ONSITE SEWAGE DISPOSAL SYSTEM

PROPERTY ADDRESS: 12225 Basslers Way
 SUBDIVISION: Walnut Creek LOT: 17 TAX ID: 05-454425
 CONTRACTOR: Freedom Septic EMAIL: _____
 CONTRACTOR ADDRESS: 2809 Liberty Road, Eldersburg, MD 21784 PHONE: 410-795-2947
 PROPERTY OWNER: Trinity Quality Homes EMAIL: _____
 OWNER ADDRESS: 3675 Park Avenue Ste 301, Ellicott City, MD 21043 PHONE: 443-324-9806

Walnut Creek Lot 17

WALNUT CREEK - LOT 17
 12225 BASSLERS WAY
 ELLICOTT CITY, MD 21042

MODEL DH071 / DR071
 DETAIL SHEET

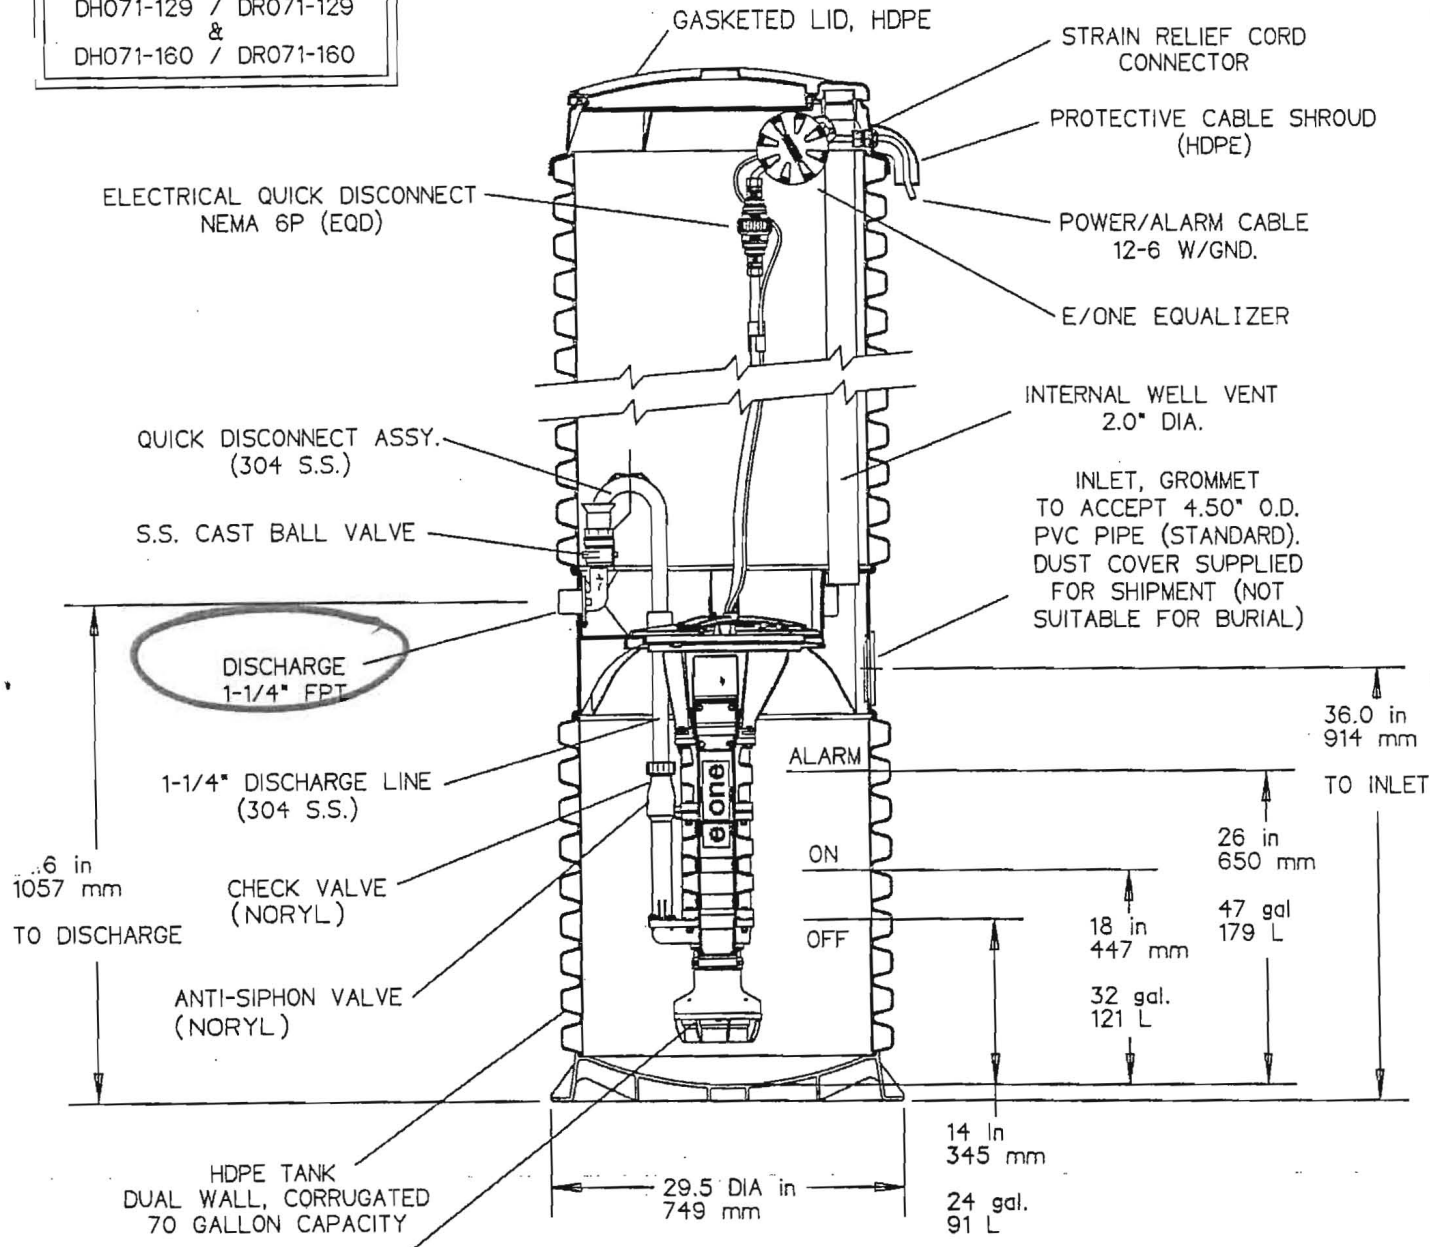
Hi Rob. I'm reviewing the septic plans for WC lots 15 and 16 and noticed something I missed on lot 17, approved in July. The force main for all is shown at 1.25". My instinct is that this is too small a diameter for a grinder pump with the solids involved. I would guess a 2" diameter is minimum for a grinder. Do you want me to change the plan to indicate 2" force main, or do you have something from the pump manufacturer stating that 1.25" is sufficient? Thanks

The discharge line from any individual E One grinder pump is 1-1/4" (see attached catalog detail). The line size becomes larger when multiple pump discharges are incorporated into a single low pressure main. For our situation there is an individual line for each proposed E One up to the installed E-One units located at the road.

From my history with grinder pumps, the size of the discharge is kept to 1-1/4" so that the discharge is forced to move a certain amount. If they designed the discharge larger the effluent would have more of an opportunity to harden/dehydrate in the line.

1,000 Gallon Pump Chamber. Wabnet Creek #17
 w/ E-One Model DH-071 Grinder Pump

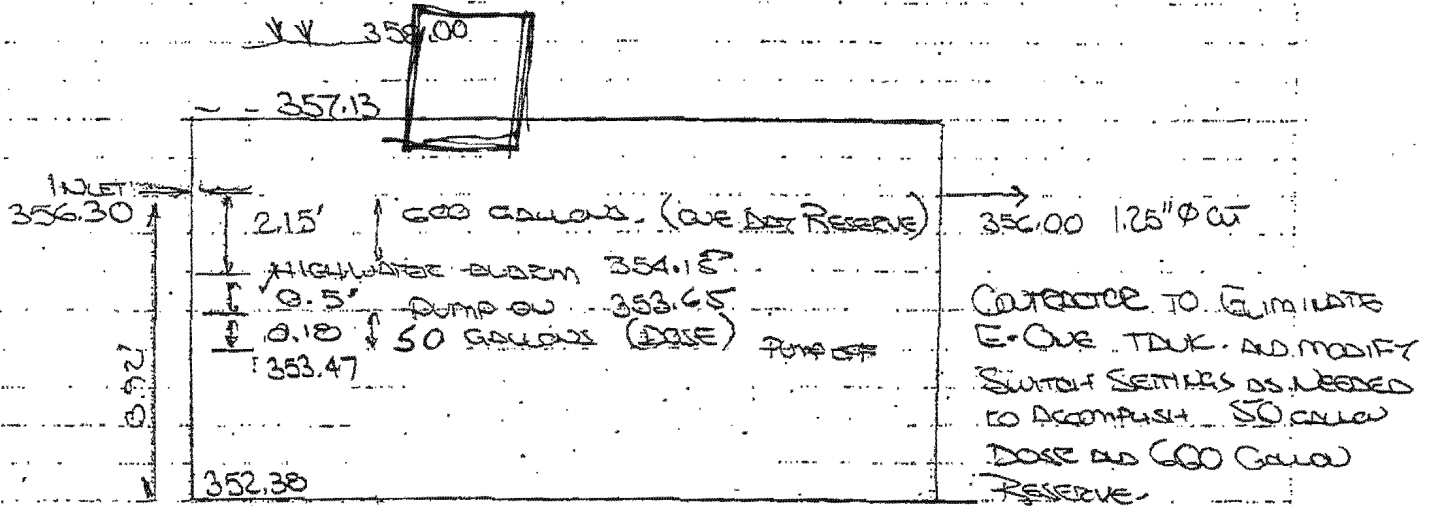
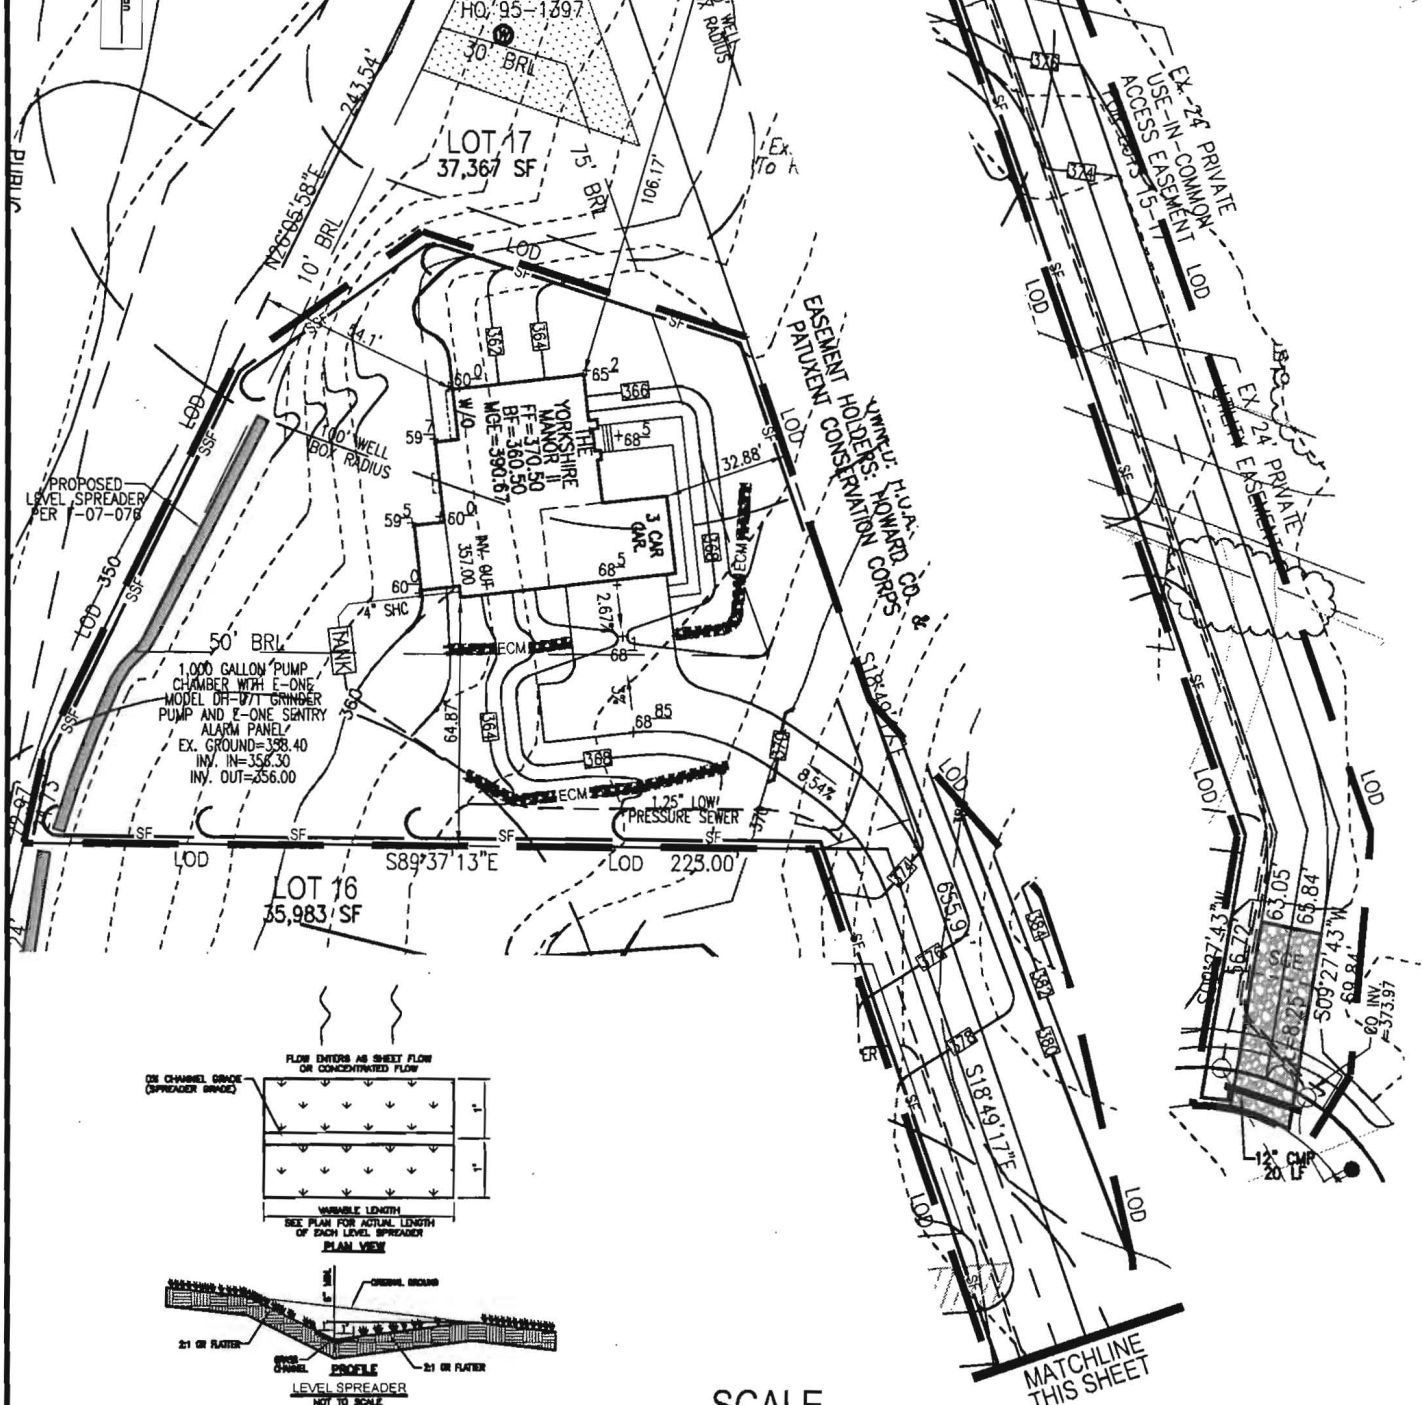
~~Provide~~ site layout cross-section with 7% SHC, tank, pump, grinder pit

PUMP CHAMBER PROFILE - LOT 17
 SCALE: HORIZONTAL - 1"=50'
 VERTICAL - 1"=5'

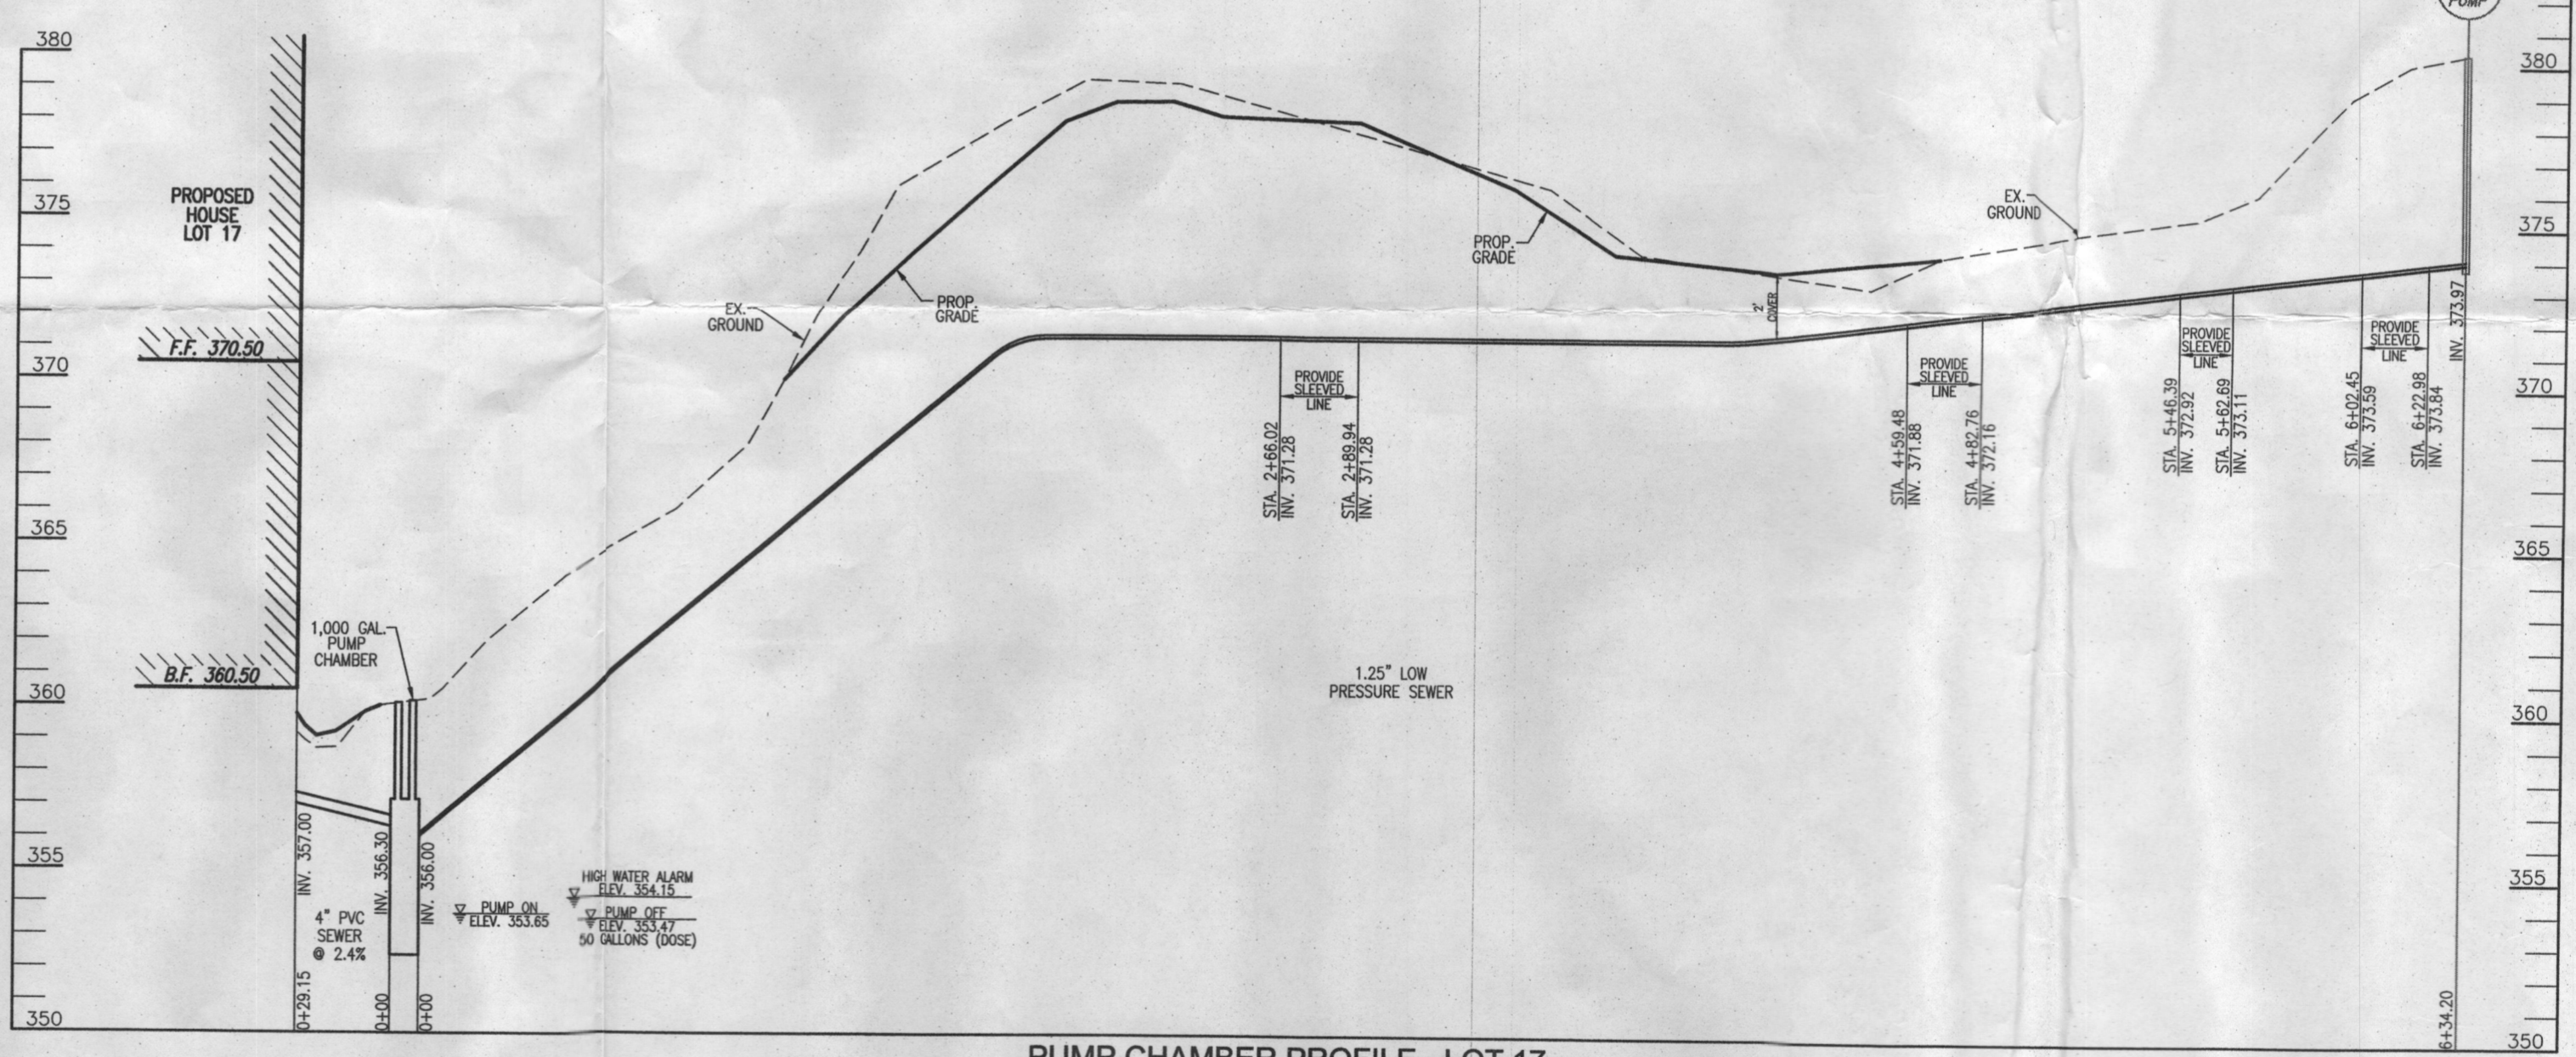
I have reviewed the floor plans for Lot 17. The floor plans are good. After looking at the Plot Plan, I did see a 1000 gallon pump chamber was proposed. We will need to see a cross section of that pump chamber. In addition, we will need to see the grinder pump design spec, model number, calculations on dose and head, etc. When you get everything together for that pump chamber we will take a look at it.

I reviewed the design specs. It all looks good. I will just need a better visual quality of the specs sheet, I had trouble reading it at first. I will need a cross-sectional diagram of the tank with elevations and piping connections with slope percentages from the house to the tank, and from the tank to the grinder pump. The high water alarm will need to be placed on the cross-section. The pump curve that you supplied to me will work, unless you just want to put it all on the same document.

1,000 GALLON PUMP CHAMBER W/ E-ONE MODEL DH-071 GRINDER PUMP
 OUTSIDE TO OUTSIDE DIM: 8.83' x 5.25'
 INSIDE TO INSIDE DIM: 8.16' x 4.58'
 INSIDE CROSS SECTIONAL AREA: 37.37 SF

600 GALLONS / 7.48 GAL./FT³ = 80.21 FT³
 80.21 FT³ / 37.37 SF = 2.15'
 50 GALLONS / 7.48 GAL./FT³ = 6.68 FT³
 6.68 FT³ / 37.37 SF = 0.18'

USE E-ONE PUMP - 1 HP PUMP CURVE
 $(50)(1.0) / (3,960)(0.4) = 1.0$ HP
 FRICTION: $785 + (2.4 \times 4) = 795' = 7/100 = 32'$
 STATIC: $373.97 - 356.00 = 18.0'$
 TDH = $32' + 18' = 50'$
 QH = 17.8 GPM
